City of Rocklin
Construction Specifications
Improvement Standards
Standard Drawings
March 2006 Edition

Errata Sheet 1

| TYPICAL LOOP DETECTOR LAYOUT | |

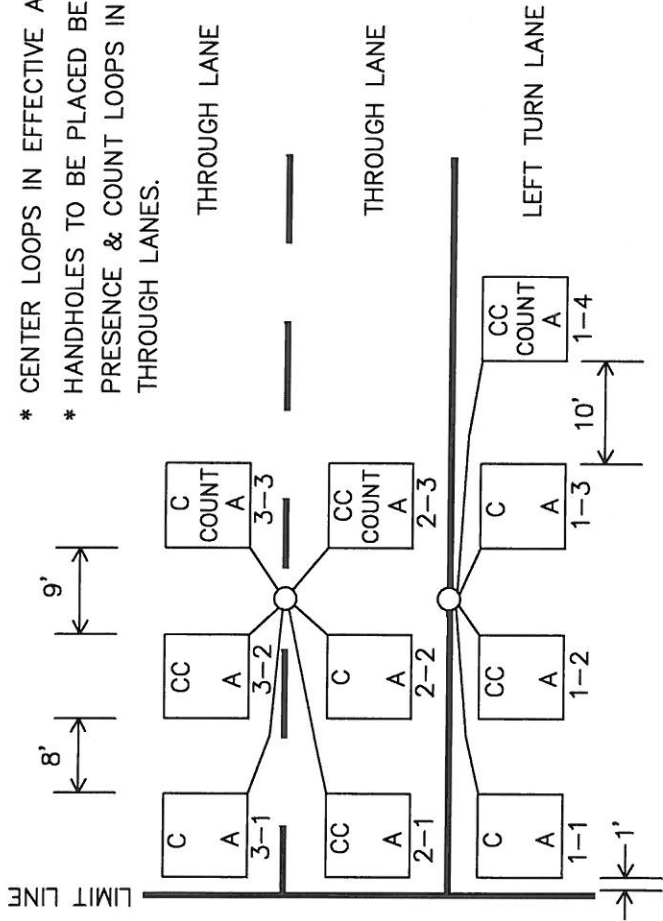
2. Replace Standard Drawing 8-5 with the attached new drawing.
